September 23, 2003

APPLICANT: Omaha Public Power District

FACILITY: Fort Calhoun Station, Unit 1

SUBJECT: SUMMARY OF MEETING WITH OMAHA PUBLIC POWER DISTRICT (OPPD) TO DISCUSS DRAFT RESPONSES TO REQUESTS FOR ADDITIONAL INFORMATION (RAIs) FOR THE RENEWAL OF THE OPERATING LICENSE FOR FORT CALHOUN STATION, UNIT 1 (FCS)

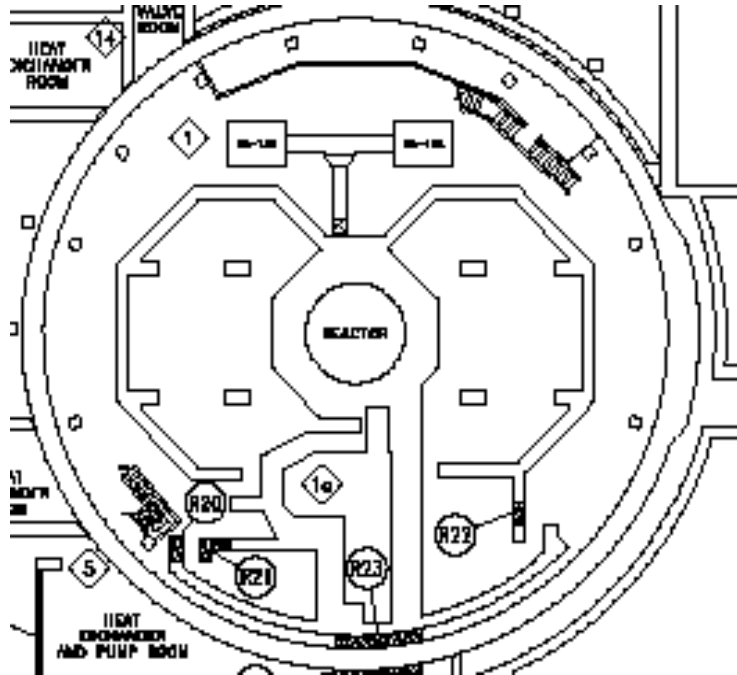
3.5.3-D1

Based on the information in LRA Table 3.5-3, row number 3.5.3.04, and in FCS AMP B.2.10, the applicant plans to inspect and review the masonry walls in accordance with enhanced GALL program XI.S5, "Masonry Wall Program." As the ungrouted masonry walls in containments are subjected to higher sustained temperatures (> 110°F), humidity, and radiation, please provide the following information for the staff to make a reasonable conclusion regarding the adequacy of these walls during the extended period of operation:

1. The masonry walls in containment are identified as R20, R21, R22, and R23 in the following figure of the 989' elevation level of containment.
